Title: Advisory Committee on Nuclear Waste
142nd Meeting

Date: Thursday, May 29, 2003

RESPONSE TO ADVISORY COMMITTEE ON NUCLEAR WASTE COMMENTS ON THE YUCCA MOUNTAIN REVIEW PLAN (YMRP)

LICENSING PROCESS FIGURE

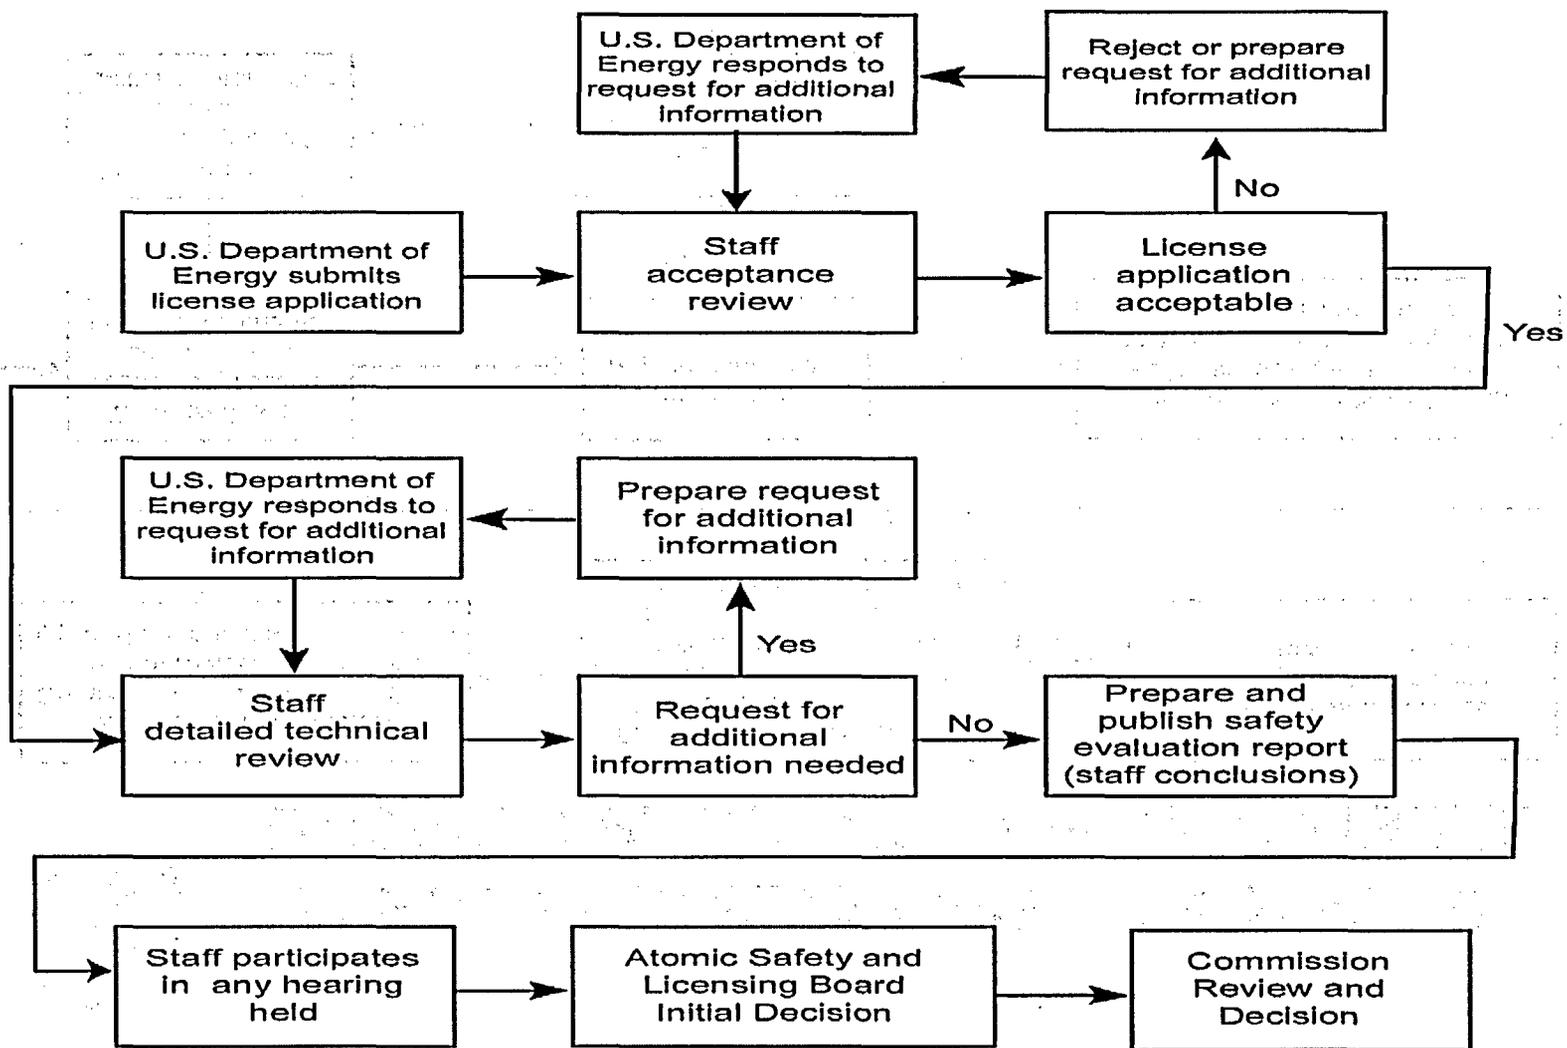
8 And, really, this box should be a triangle
9 because this is a decision point. I think there is
10 actually another block I need to add, and that's in
11 this case, that if there is a complete rejection of
12 the application because it is substantially incomplete
13 or if the staff defined that the license application
14 is sufficiently complete and a detailed technical
15 review could begin down here but additional
16 information is needed in limited areas. That kind of
17 gets you into this loop here.

1 some of these blocks, some of the typical logic
2 shapes, such as a diamond for decisions and what have
3 you, that it would improve it a little.

4 Is there any chance that on the critical
5 blocks, you could indicate a range of time that is
6 involved in order to telegraph the fact that some of
7 these boxes happen, take hours, and some of them take
8 months?

- The Yucca Mountain Review Plan is very repetitive.
- Although this repetitiveness supports uniform reviews, it adds to the length and complexity of the review plan.
- Tables, charts, and graphics could be used to communicate the completeness and improve the understanding of the plan.

9 MR. CIOCCO: Certainly, yes, yes. And
10 that's a good point. For instance, the acceptance
11 review is a 90-day --

- Staff agrees the YMRP is lengthy and sometimes redundant.
- The goal was to provide staff reviewers with sufficient information to conduct the review in discrete areas.
- Two Figures Have Been Added to a New Appendix A
 - Licensing process
 - Hypothetical review of a typical license application section.
- New YMRP text explains the graphics.

HYPOTHETICAL REVIEW OF A TYPICAL LICENSE APPLICATION SECTION FIGURE

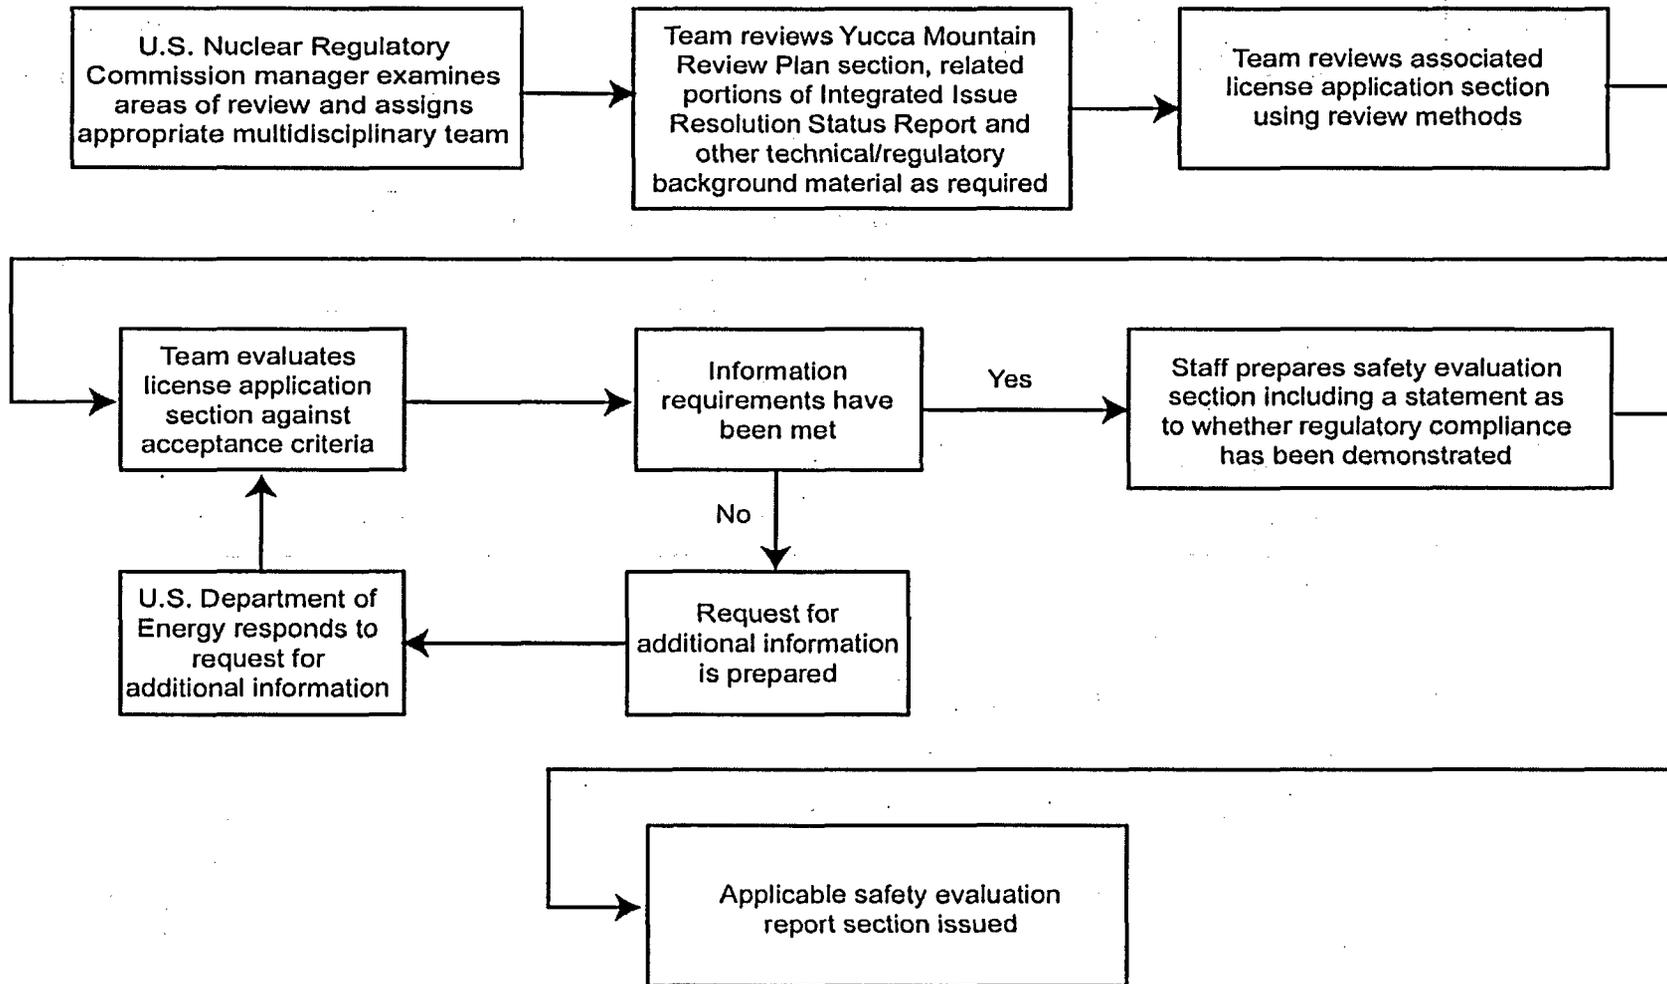
13 A review example of a specific issue would
14 help reviewers and the applicant understand how the
15 review plan would be used. The example should
16 illustrate how data items, such as data sufficiency
17 and model adequacy, are determined at the detail
18 level. So that was your comment.

- The Yucca Mountain Review Plan reflects the risk perspectives of Part 63 and allows the applicant flexibility in demonstrating compliance.
- However, the manner in which the review plan is applied will determine whether a risk-informed, performance-based process is used for a licensing decision.
- A review example of a specific issue would help reviewers and the applicant understand how the review plan would be used.
- The example should illustrate how data items such as data sufficiency and model adequacy are determined at the detailed Level.

19 The staff response, staff agrees. A
20 review example and documentation of these results has
21 been incorporated into Appendix A of the Yucca
22 Mountain review plan. Appendix A is what was formerly
23 Chapter 1, which was the introduction. I will explain
24 that a little bit later.
